Advice to the local planning authority

To LPA	Kirklees Council
LPA planning ref no	2026/62/90857/W
Our ref	26-0570
Site address	Pearl House (Former HSBC Bank), 2 Cloth Hall Street, Huddersfield, HD1 2EG
Proposal description	Conversion and extension of sixth floor plant room to form communal space, office and plant room area including re-cladding and new window openings, external alterations including new access door openings and replacement windows (in association with previously-approved change of use of floors 1-5 inclusive to 28 flats/studios and change of use of part of ground floor to provide associated facilities for the flats/studios, including refuse store, approved pursuant to application 2025/91221) (within a Conservation Area)
Date on fire statement	No dated (published on planning register at 19.05.2026)
Date consultation received	22/05/2026
Date response sent	11/06/2026

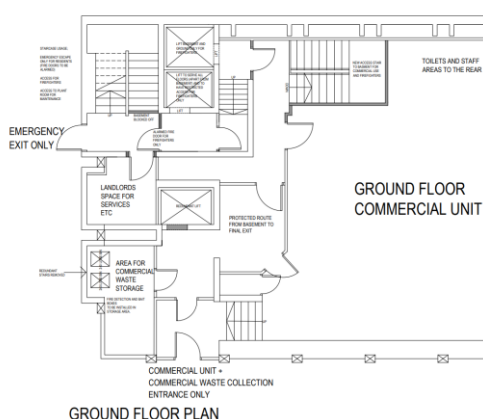
- 2.1 The proposed floor plans drawings (basement and ground floor) show that the 'Store for Ground Floor Commercial Unit' and the 'Ground Floor Commercial Unit,' communicate with the firefighting shaft which serves the residential area (flats on upper floors L1 to L5). Therefore, there is a connection between the residential and the commercial areas.

- 2.2 The adopted fire safety standard states that residential stairs in buildings of this height, should not serve other occupancies in. Accordingly, the residential areas should not communicate with the commercial areas.
- 2.3 Design changes to provide separation between these two different occupancies, in this instance, are unlikely to affect land use planning considerations, where they can be achieved by way of internal alterations. It will be for the applicant to demonstrate compliance at later regulatory stages.

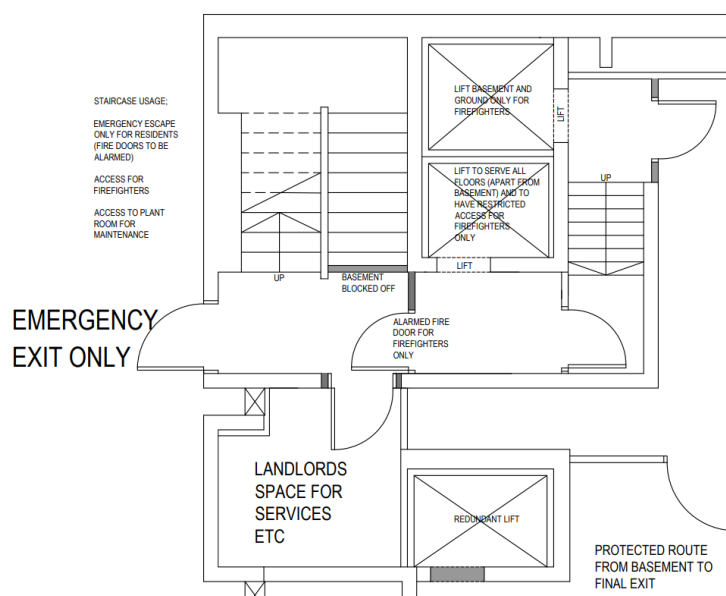
- 2.4 The proposed Ground Floor Plan drawing shows a direct connection between the 'Landlords Space for Services etc.' and the firefighting shaft/firefighting stair enclosure.

- 2.5 The relevant fire safety standard recommends for the firefighting shaft/lobby, at the fire service access level, any access to it from the accommodation should be by way of protected lobbies (extract from BS9999:2017):

- 2.6 Also, from the information provided within the planning application, it is unclear if the 'Landlords Space for Services etc.' room has a commercial or residential use. It will be for the applicant to demonstrate compliance at later regulatory stages and seek advice from the LPA about the materiality of any design changes proposed if this would necessitate a new external entrance to serve the room.

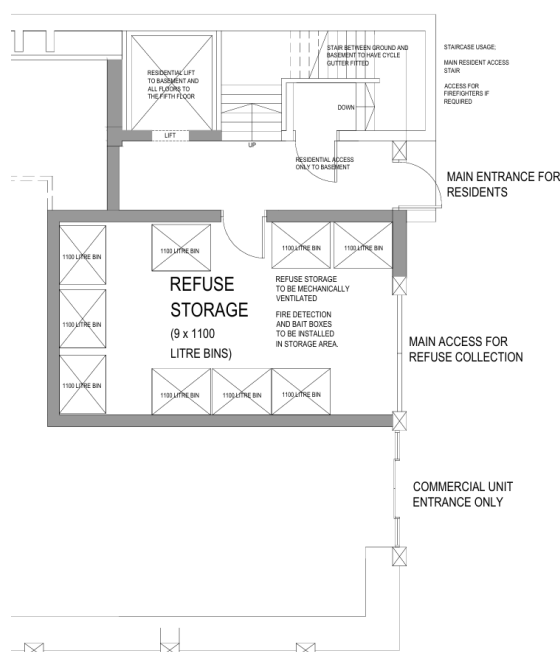
- 2.7 The proposed Ground Floor Plan drawing shows that the residential 'Refuse Storage' connects directly with the stair enclosure which is the means of escape route for residential upper storeys.

- 2.8 According to the cited fire safety standard, any access to the escape route at the fire service access level, from ancillary accommodation, should be by way of protected lobbies.

- 2.9 Design changes necessary to comply, in this instance, are unlikely to affect land use planning considerations, where they can be achieved by way of internal alterations. It will be for the applicant to demonstrate compliance at later regulatory stages.
